Proposal Request

Project:
Intermountain Healthcare Lake Park Level 1 Remodel
2545 College Drive
Murray, Utah 84123

Date: 02/11/2021
Proposal Request
PR # 01

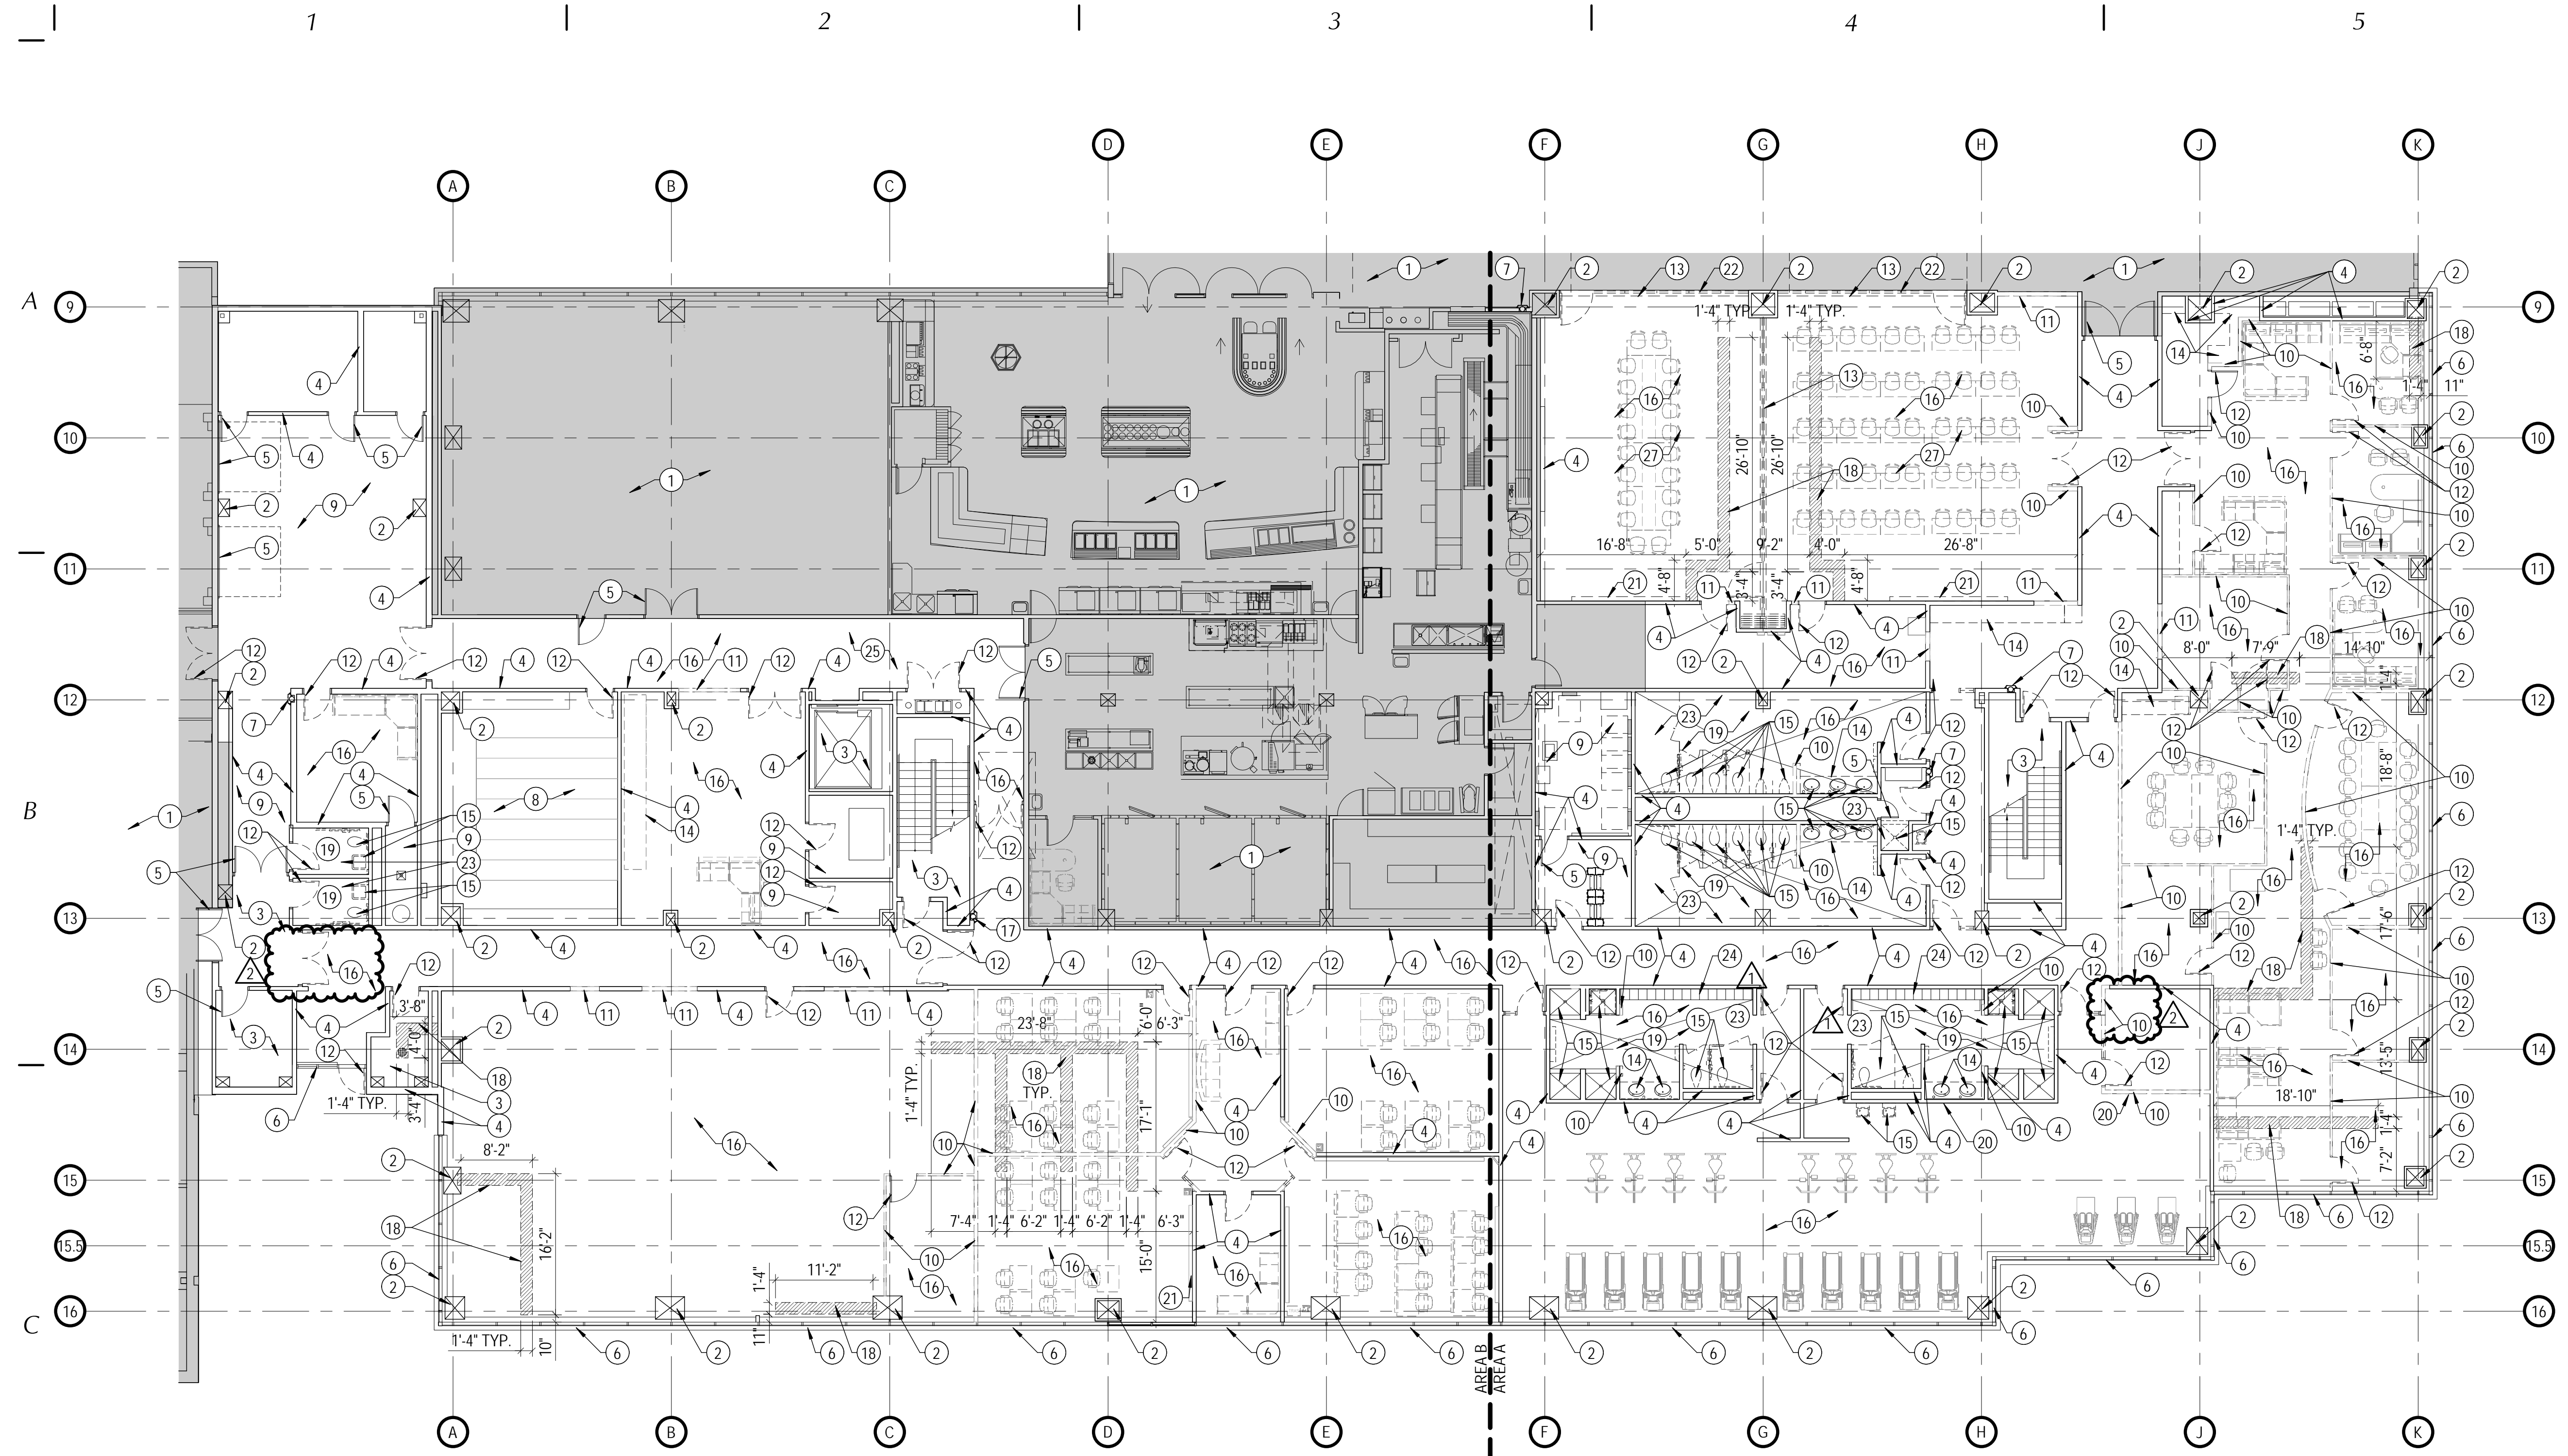
- Existing Blinds:** The contractor asked whether the existing blinds need to be removed. Yes, whereas the AI101 specifies that the new windows are to receive new window shades. The existing shades will need to be demolished. See the revised AD101.

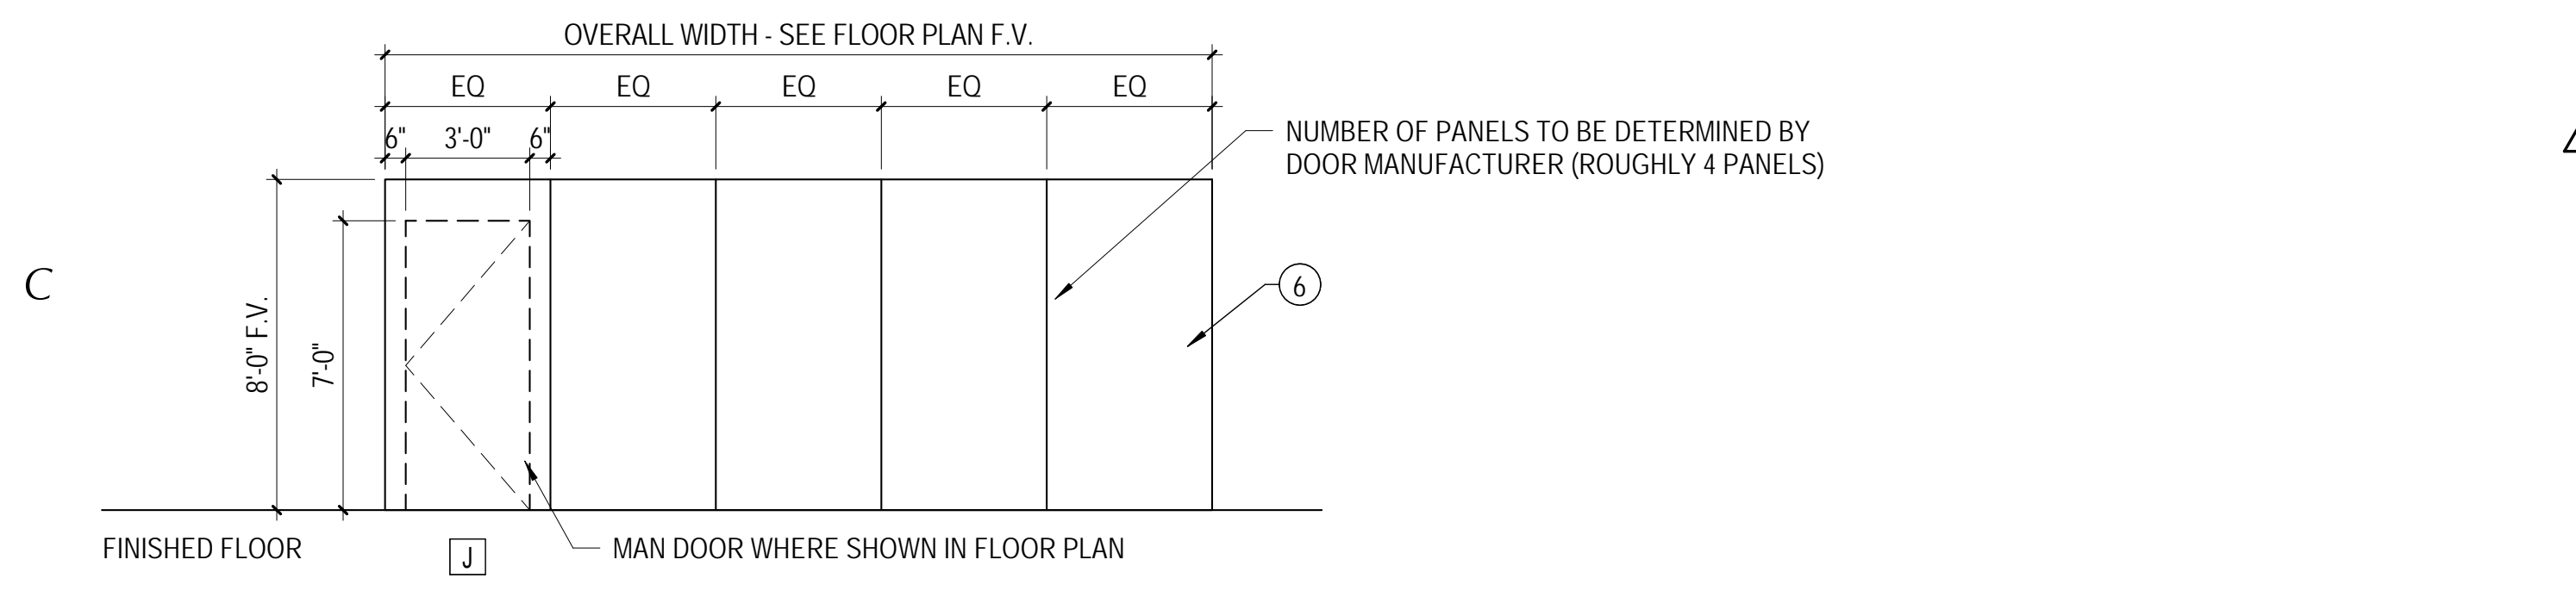
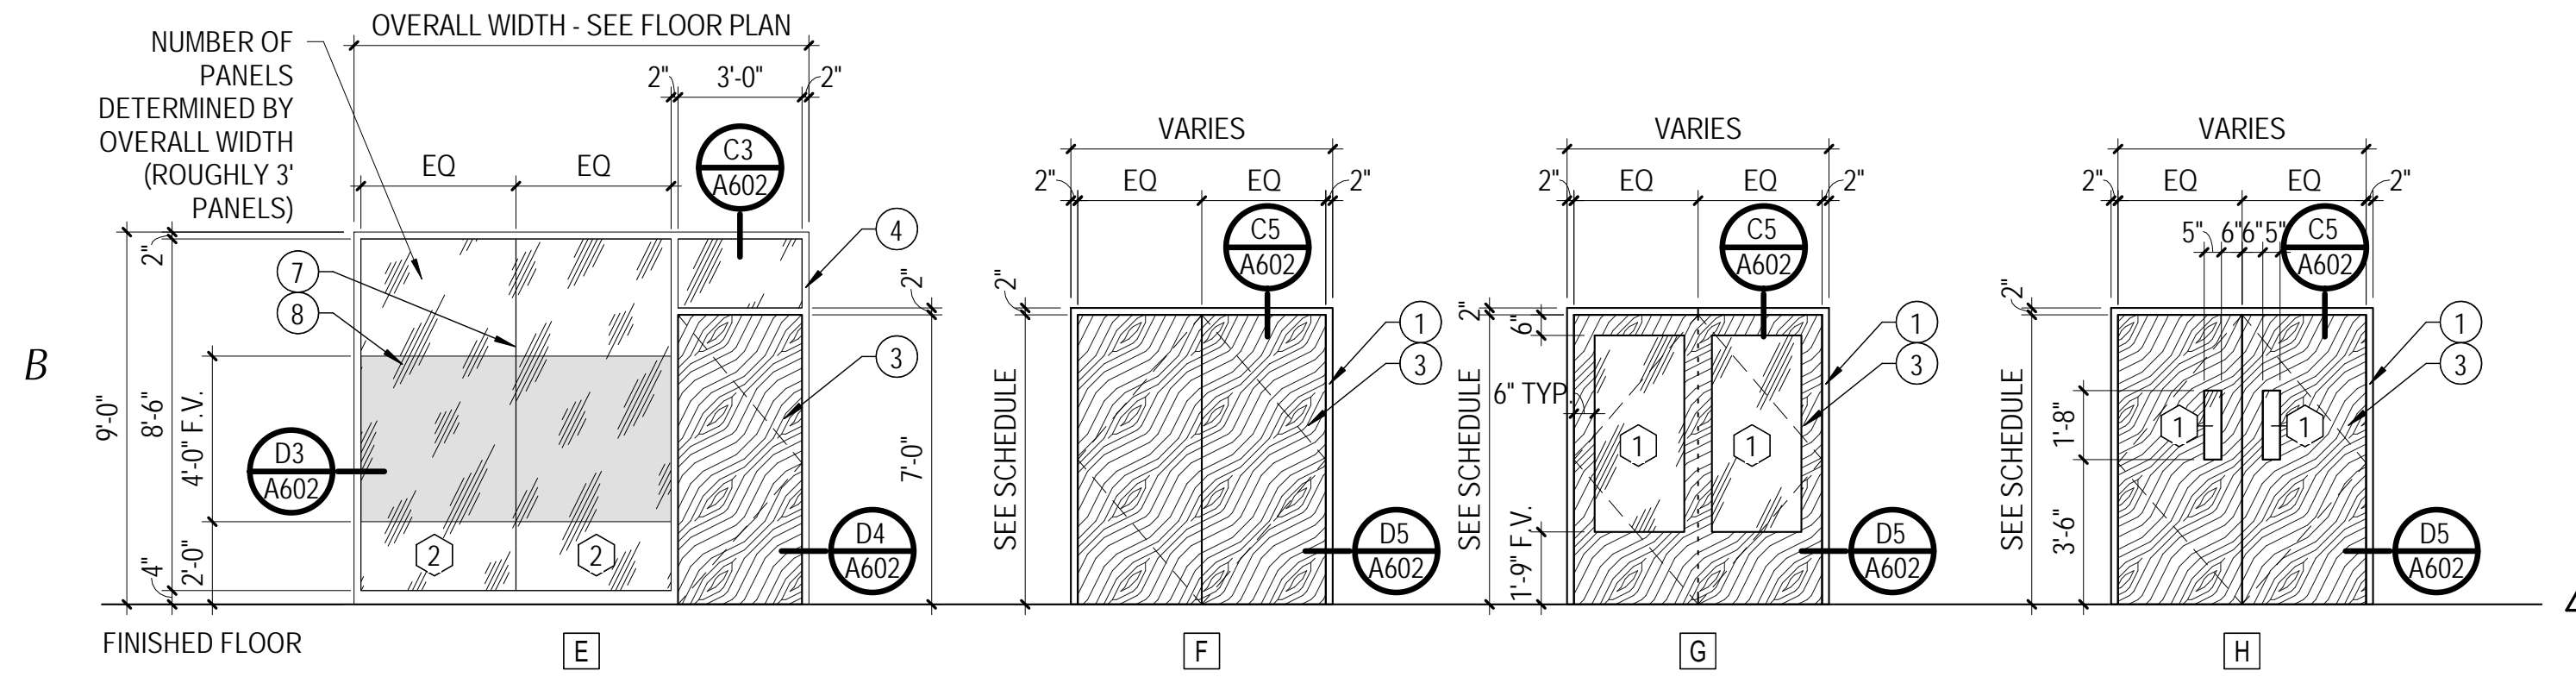
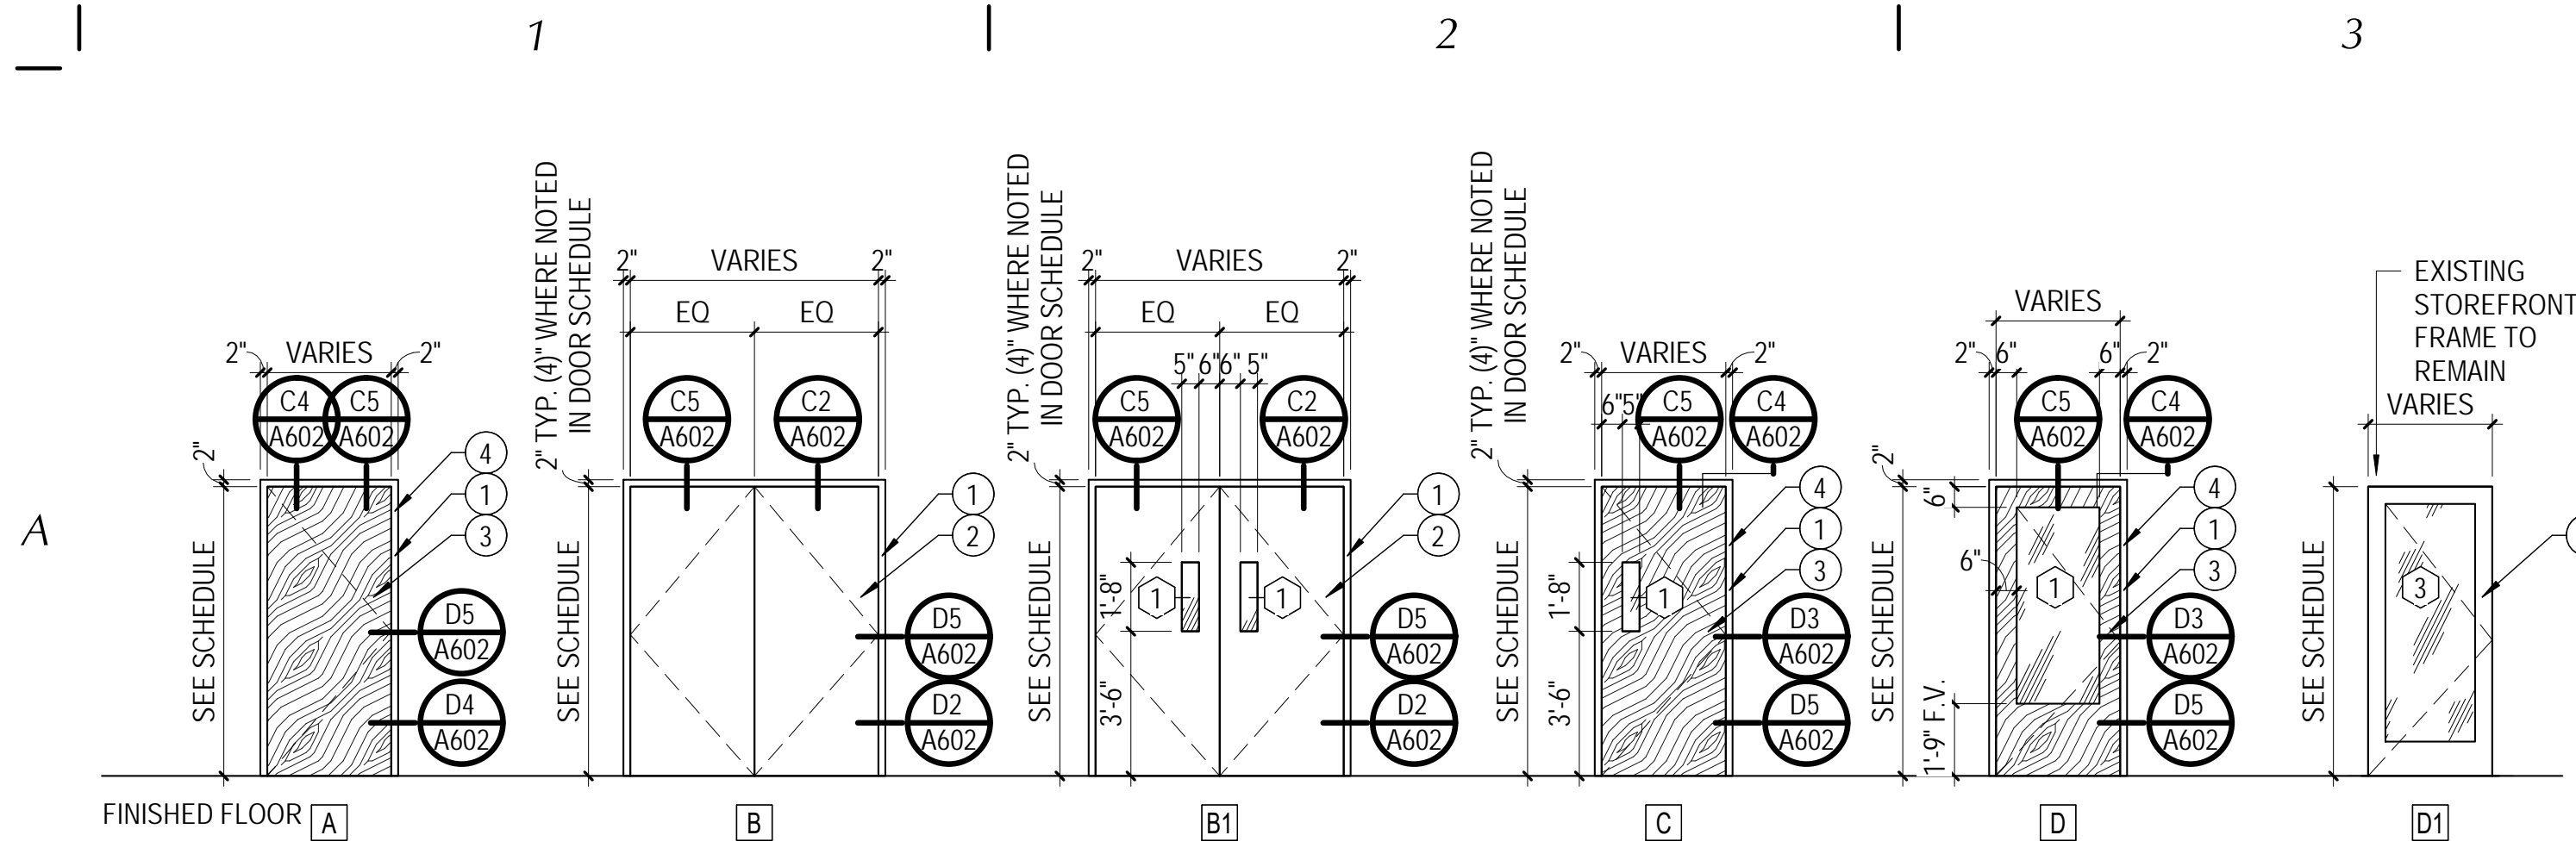
5. **Door Modifications:** In coordination with the Contractor, there are several door frames that will now be left in place. Their frame designations in the door schedule have been modified to indicate existing. This applies specifically to doors: 125, 139, 141, 149, 149a, and 150. The Contractor shall verify all door frame prep required for the new conditions to determine if the existing frame can be reused. The Contractor shall verify, patch and repair the frame to assure that it will ultimately be in like new condition upon completion. Door 131a's swing has been modified to match existing conditions. Additionally, per Owner request, Door 131a has been removed from the scope of the project. The existing door needs to be painted and adjusted to be in like new condition. Please provide the applicable credits. Additionally, per Owner request Door 121 has been enlarged to 3'-6" to allow for larger by gym equipment, which required the modification of adjacent walls and ceiling. See the revised AD101, A101, A101A, A101B, A151, A601, A1101, and EL151.

10. **Window Frame Type:** Per Owner request, the new aluminum window type shall be a standard storefront system to match existing rather than the wraparound Western Integrated system that was specified. The finish conditions of this system need to be coordinated with the Architect and Owner. See the revised A601.
